**CITY OF SACRAMENTO DESIGN REVIEW AND PRESERVATION BOARD
RECORD OF DECISION**

Project Name: Morey Place
Project Number: P06-021
Project Location: Between Morrison and Morey Avenue, East of Western Avenue
Assessor's Parcel No.: 250-0352-005, 006, 008
Applicant: Russell Stone, Willow Equities
Action Status: Approved with Conditions Action Date: 02/22/07

Exhibit 1-B Tentative Map

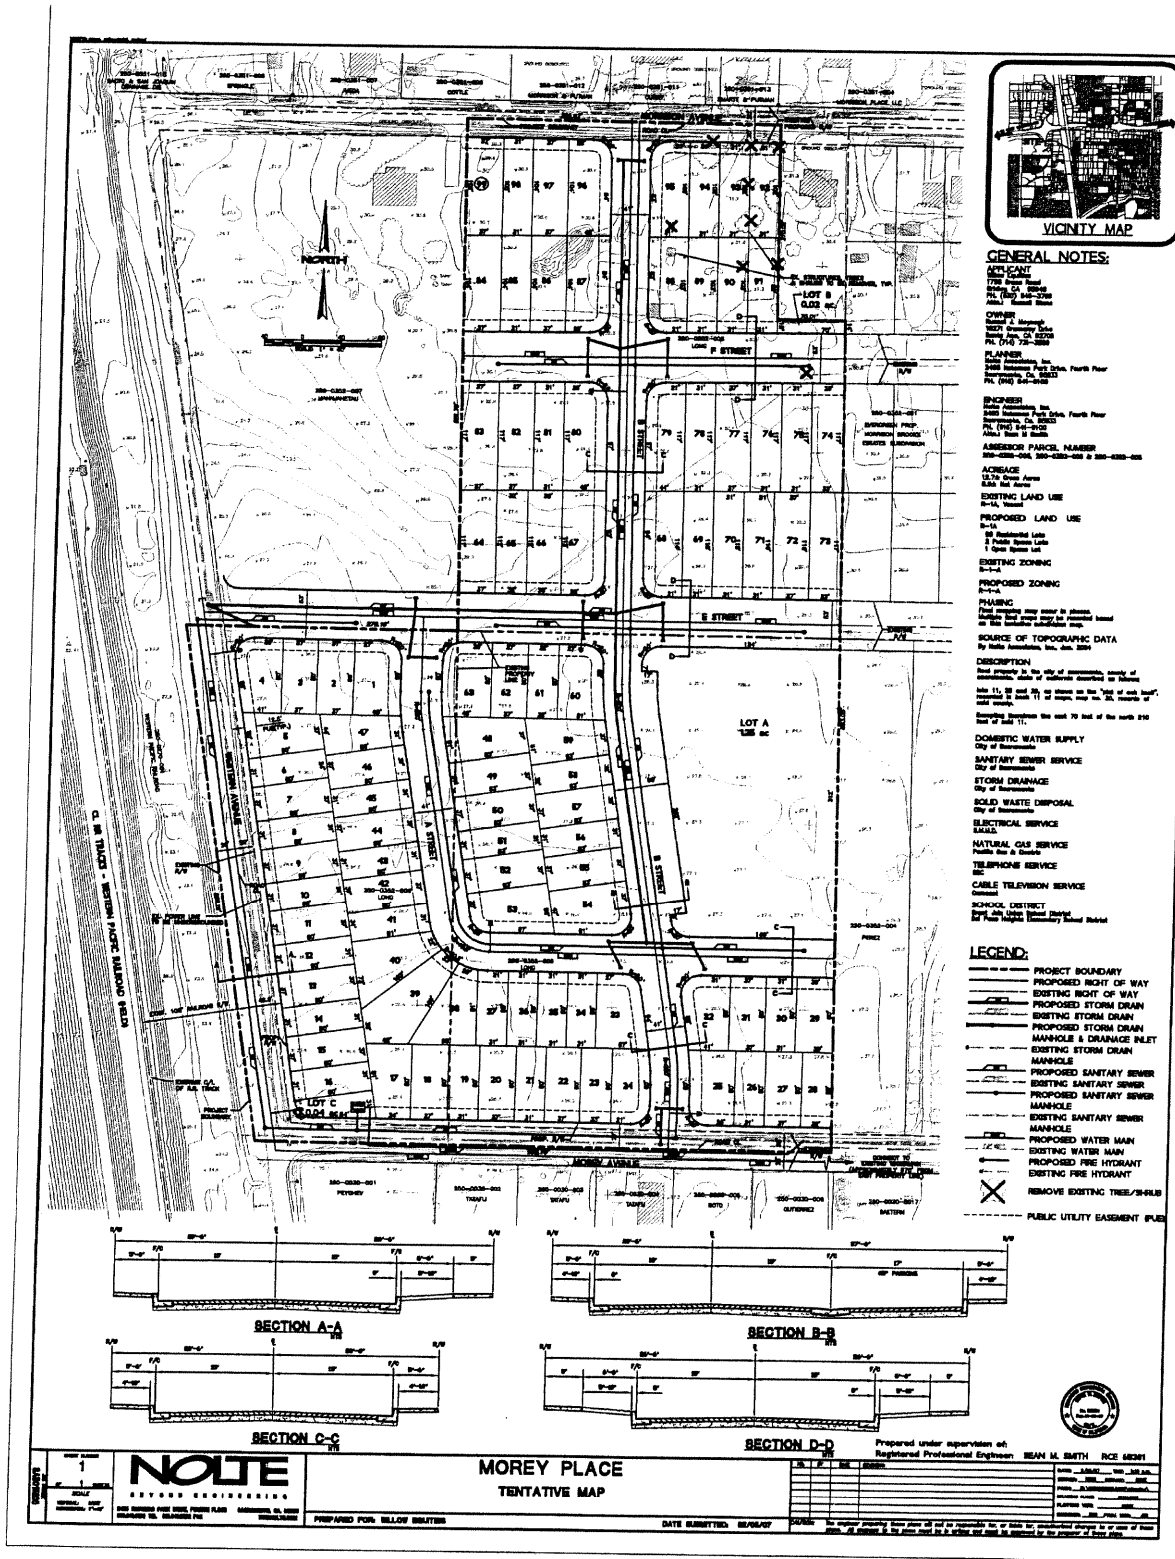
NOTE: These conditions shall supersede any contradictory information shown on the Tentative Map approved for this project (P06-021). The design of any improvement not covered by these conditions shall be to City standard.

10. Dedicate and construct streets F Street shown on the tentative map to a City standard 53-ft right of way street cross-section to the satisfaction of the Development Engineering Division.

11. Dedicate and construct E Street shown on the tentative map to a City standard 53-ft right-of-way street cross-section. However, where the street is adjacent to the future park, the side of the street that is directly adjacent to the park shall have parallel parking striping in-lieu of the standard planter. The other side of the street shall remain to City standards. The design and construction of E Street shall be to the satisfaction of the Development Engineering Division.

12. Dedicate and construct A Street shown in the tentative map to a City standard 41-ft right of way street cross-section to the satisfaction of the Development Engineering Division.

17. All street round corners shall have a 27-ft radius measured from the face of curb.
18. The applicant shall eliminate lot B shown in the tentative map to the satisfaction of the Development Engineering Division.

37. Park Dedication – IOD: Pursuant to Sacramento City Code Chapter 16.64 (Parkland Dedication) the applicant shall provide on City's form an irrevocable offer of dedication (IOD) of the parks site identified on the tentative map as Lot A comprising 1.25+/- (gross) acres. At the time of delivery of the IOD, the applicant shall enter into an Agreement with the City to (1) provide to City a title report demonstrating that it holds full and clear title to Lot A, including all interests necessary for maintenance and access; (2) provide a Phase 1 environmental site assessment of Lot A; (3) if the environmental site assessment identifies any physical conditions or defects in Lot A which would interfere with its intended use as a park, as determined by the Park Planning, Design and Development Division of the City's Department of Parks and Recreation (PPDD) in its sole discretion, applicant shall complete a supplemental assessment and remedy any such physical condition or defect, to the satisfaction of PPDD; and (4) take all actions necessary to ensure that Lot A is free and clear of any wetland mitigation, endangered or threatened animal or plant species, sensitive habitat or other development restrictions. The applicant shall be solely responsible, and at its sole cost, for any required mitigation costs or measures associated with Lot A.

Exhibit 1-O Plan 1666 Lot Plan

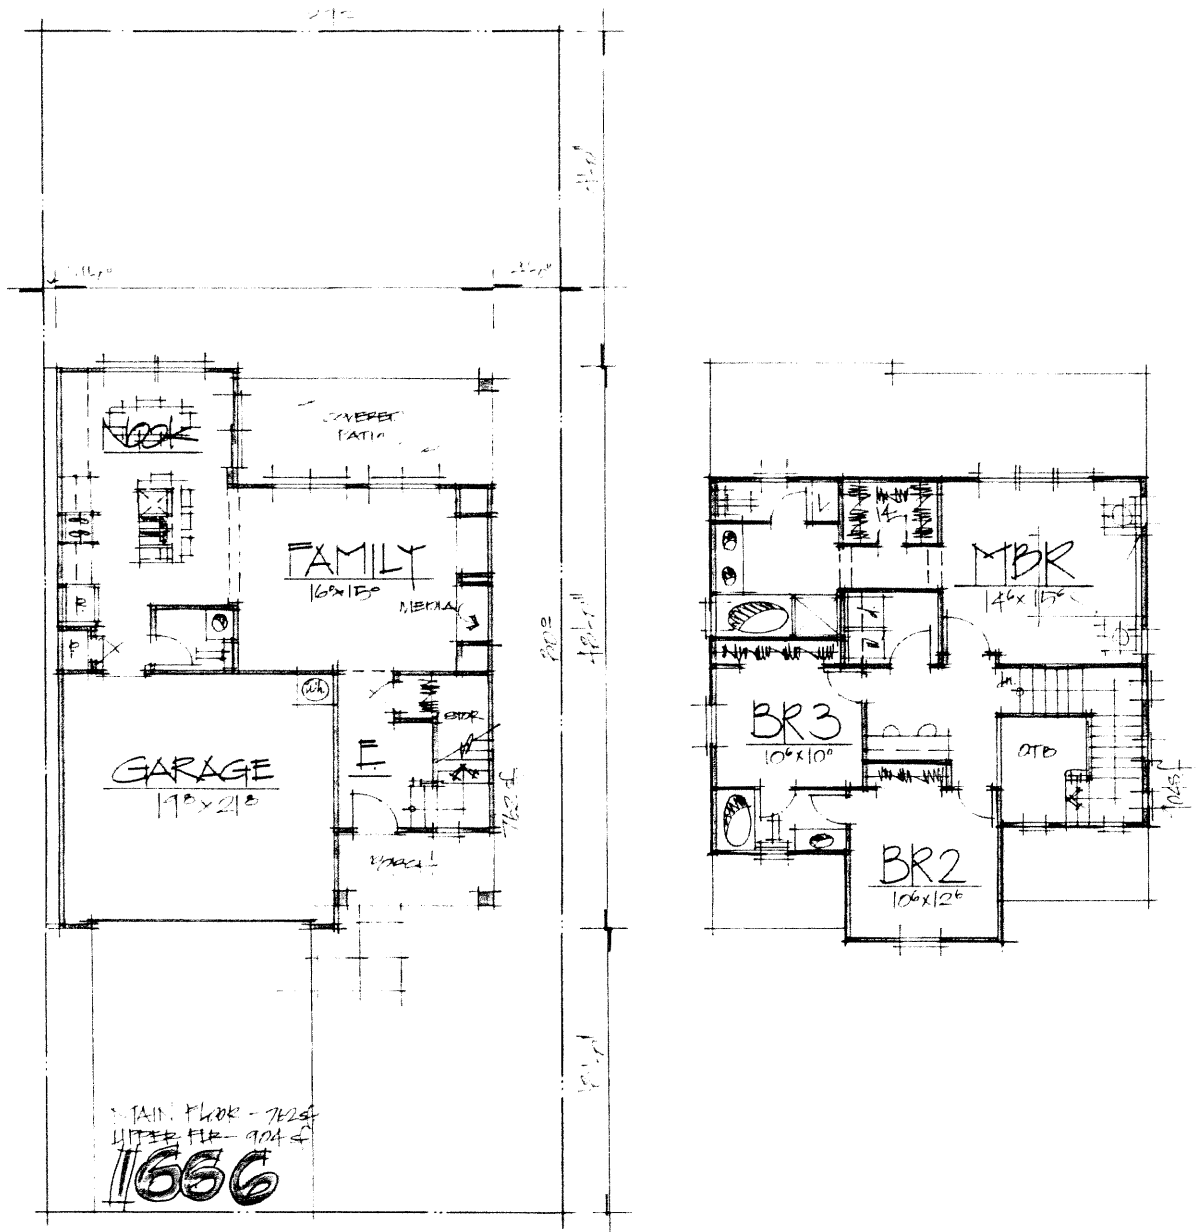
35. The applicant shall distribute the house plans throughout the development so as to provide adequate surveillance from the street, to the satisfaction of Current Planning staff. Specifically, Plan 1666 shall not be overconcentrated, as determined by Current Planning staff.
